ROCHESTER GAS AND ELECTRIC CORPORATION
DOCKET NO. 50-244
R. E. GINNA NUCLEAR POWER PLANT
AMENDMENT TO FACILITY OPERATING LICENSE

Amendment No. 36
License No. DPR-18

ATTACHMENT TO LICENSE AMENDMENT NO. 36

SAFETY EVALUATION BY THE OFFICE OF NUCLEAR REACTOR REGULATION
SUPPORTING AMENDMENT NO. 36 TO FACILITY OPERATING LICENSE NO. DPR-18

FIGURE 3.10-1
CONTROL ROD INSERTION LIMITS VERSUS CORE POWER
FOR BOL THROUGH EOL

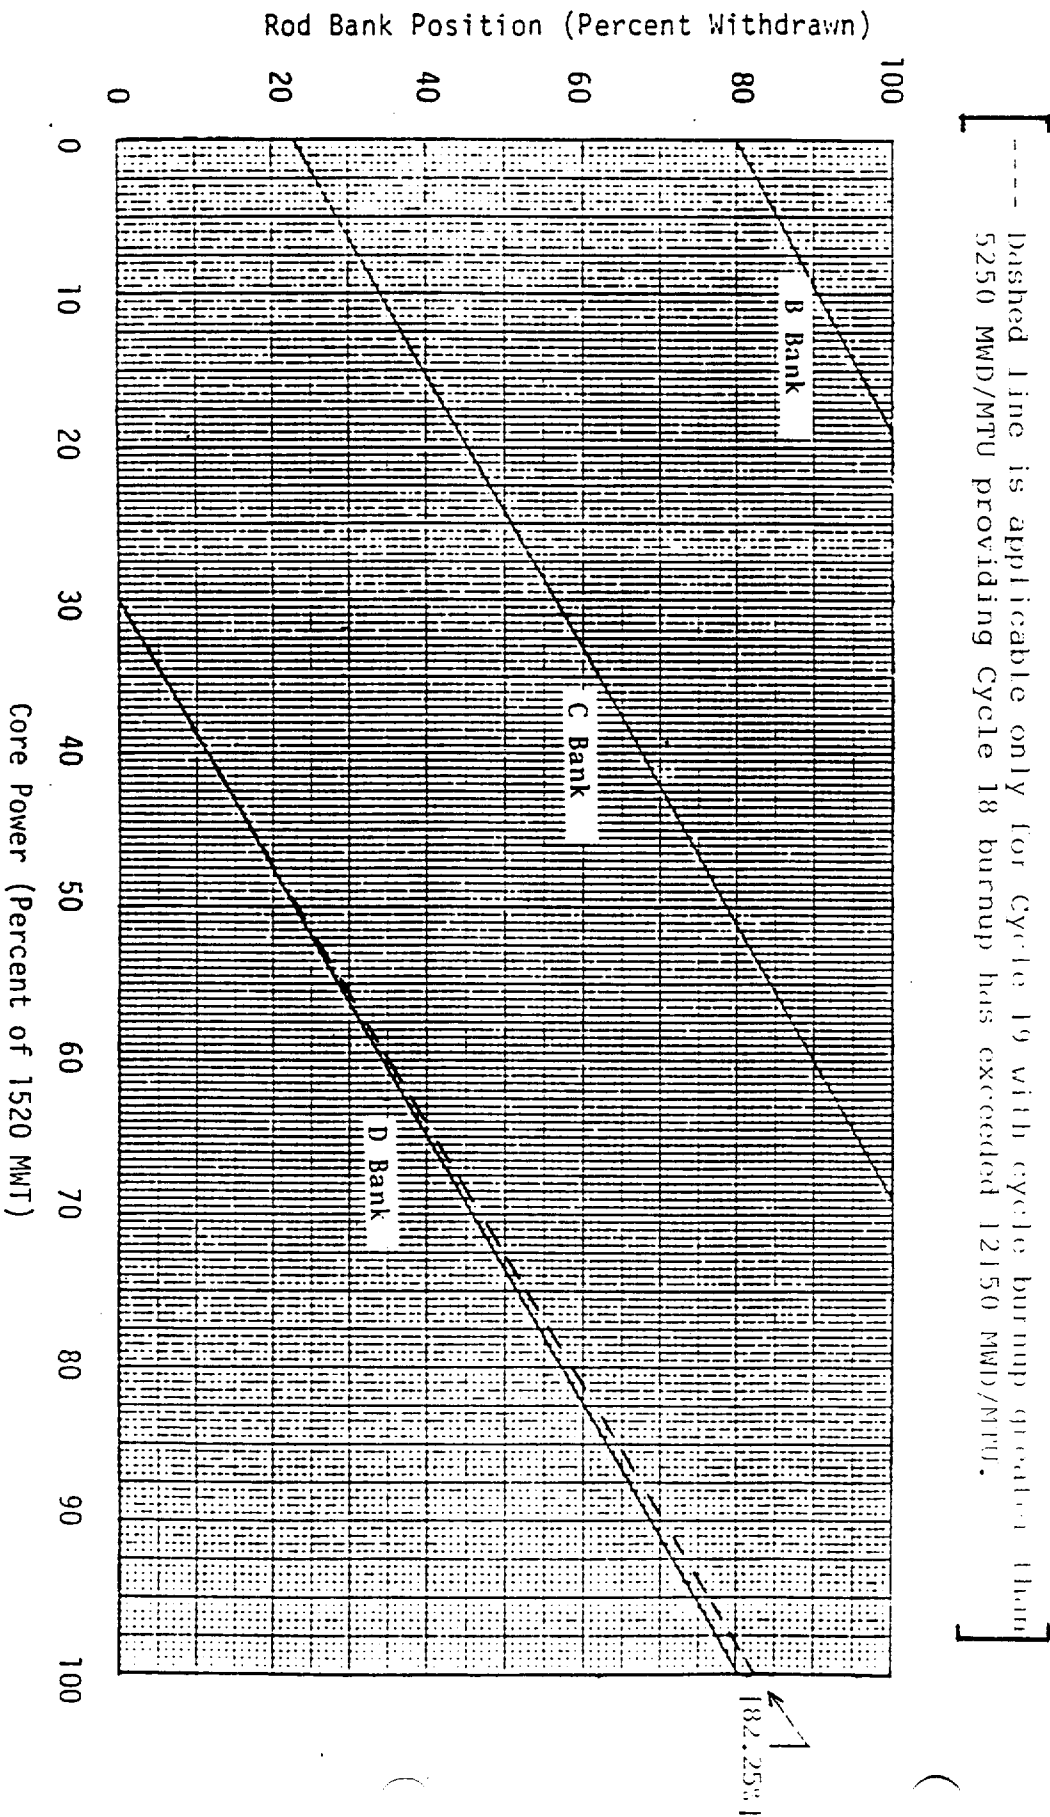
The Cycle 19 reload has been designed by Westinghouse using standard design methodology. Based on this methodology, all criteria for the reload are met provided a slight adjustment is made to the bank D insertion limits. This Technical Specification change will slightly modify the rod insertion limits for Cycle 19 to ensure all criteria are met.

The adjustment is only necessary for Cycle 19, since Cycle 18 exceeded a burnup of 12150 MWD/MTU, and is only applicable for Cycle 19 burnups from 5250 to 9500 MWD/MTU. (Since 9500 MWD/MTU is close to Cycle 19 end of cycle, the 9500 burnup has been extended to end of cycle for this application).

The amount by which the 1.66 FW limit could be exceeded with the current insertion limits varies from 0% at a Cycle 18 burnup of 12150 MWD/MTU to a maximum of 0.33% at a Cycle 18 burnup of 12300 MWD/MTU. The limit is not exceeded if the bank D insertion limit is raised by 2.25% (5 steps) at full power. Since this change is not applicable to future cycles, it is a change with a limited period of applicability with appropriate qualifiers. No other safety criteria are affected by the Cycle 19 core reload.

The proposed change would require the bank D control rods to be withdrawn 5 steps farther during full power operation. Withdrawing the rods above the insertion limit increases the shutdown margin, decreases the ejected rod worth, reduces power peaking, and does not alter stuck rod worth. Therefore, withdrawing the rods is conservative and ensures that the safety criteria for the Cycle 19 reload are met, there is no significant increase in the probability or consequences of an accident previously evaluated. Thus the staff finds the proposed change acceptable for Cycle 19.
